Docket Items #6 & #7
BAR CASE # 2017-00472
2017-00473

BAR Meeting
March 7, 2018

ISSUE: Partial Demolition & Addition/Alterations

LOCATION: 419 North Columbus Street

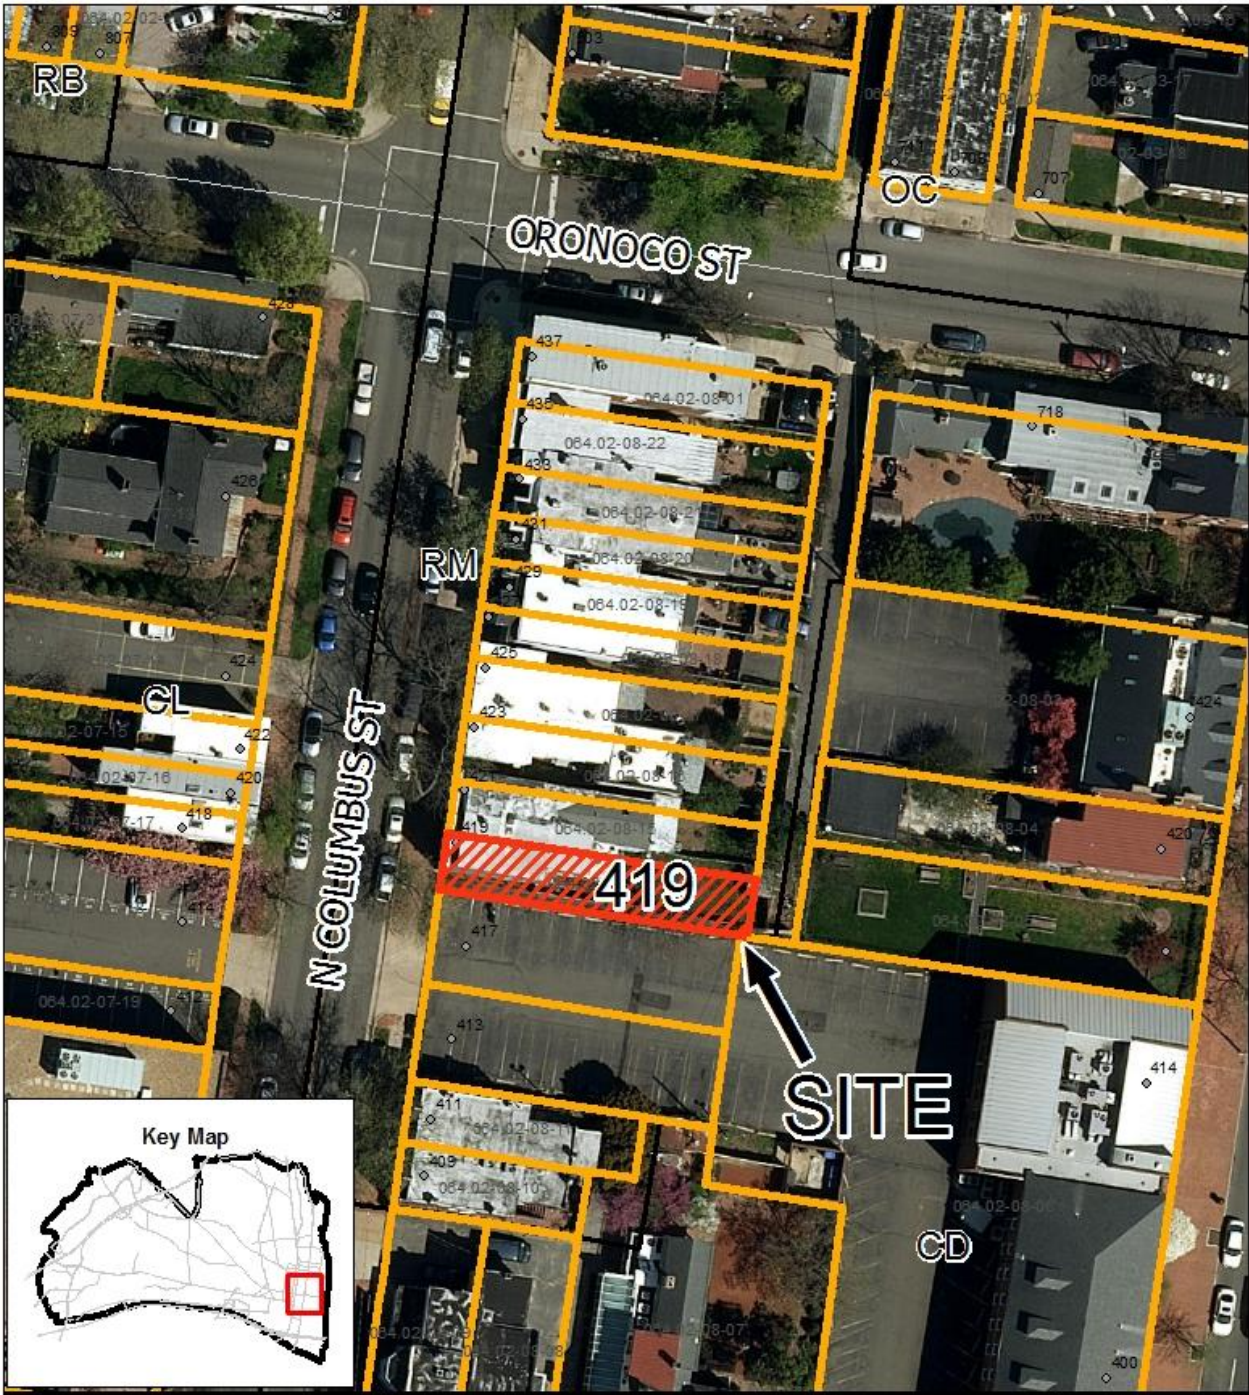
1. The applicant must work with staff to evaluate whether historic siding and historic windows exists on the main block and must retain and repair the historic elements if determined feasible by staff. The applicant must work with staff for final design details for the window trim, cornice and door surround, based on the presence of historic original elements found at the adjacent property at 421 N Columbus.

2. The siding on the west elevation of the addition should match the board and batten siding used on other parts of the addition. Remove the panels proposed on the south elevation.

3. Final approval of the specifications for the fire-rated windows to be made by staff to ensure that the windows are as close to conformance with the BAR's Window Policy as possible, while still complying with the building code.
